UNITED STATES
DEPARTMENT OF THE INTERIOR
BUREAU OF LAND MANAGEMENTFORM APPROVED
OMB NO. 1004-0137
Expires: January 31, 2018**SUNDRY NOTICES AND REPORTS ON WELLS**
*Do not use this form for proposals to drill or to re-enter an abandoned well. Use form 3160-3 (APD) for such proposals.*5. Lease Serial No.
NMSF078828A

Plug And Abandonment Procedure

GCU 40

Re: Permanent Abandonment
Well: GCU #40

Wellbore Diagram

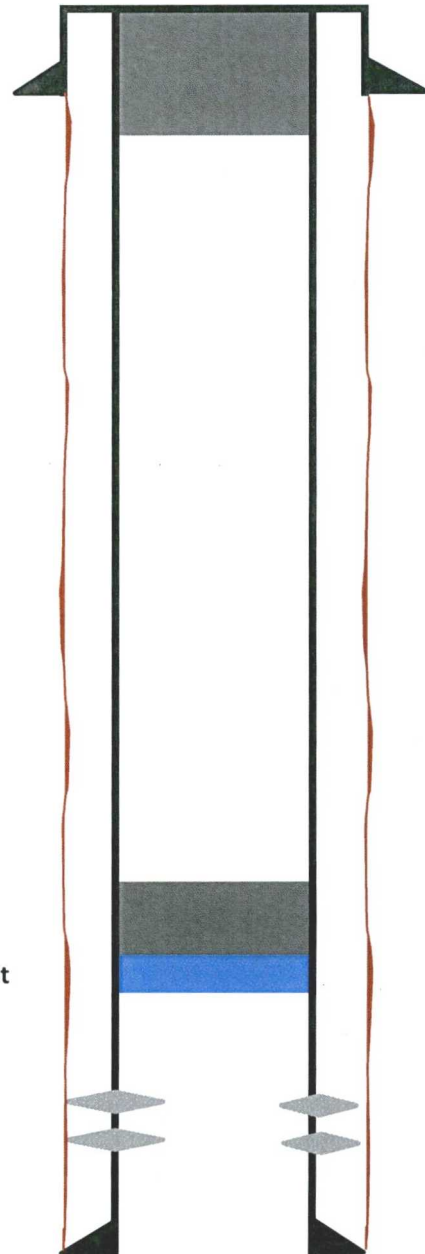
1. Plugging operations authorized are subject to the attached "General Requirements for Permanent Abandonment of Wells on Federal and Indian Lease."
2. Farmington Office is to be notified at least 24 hours before the plugging operations commence (505) 564-7750.
 1. Set plug# 1 (1222 - 961) ft. to cover the top of the Fruitland Formation. BLM picks top of the Fruitland at 1011 ft.

Operator will run a CBL to verify cement top. Submit the electronic copy of the log for verification to the following addresses: jwsavage@blm.gov brandon.powell@state.nm.us

You are also required to place cement excesses per 4.2 and 4.4 of the attached General Requirements.
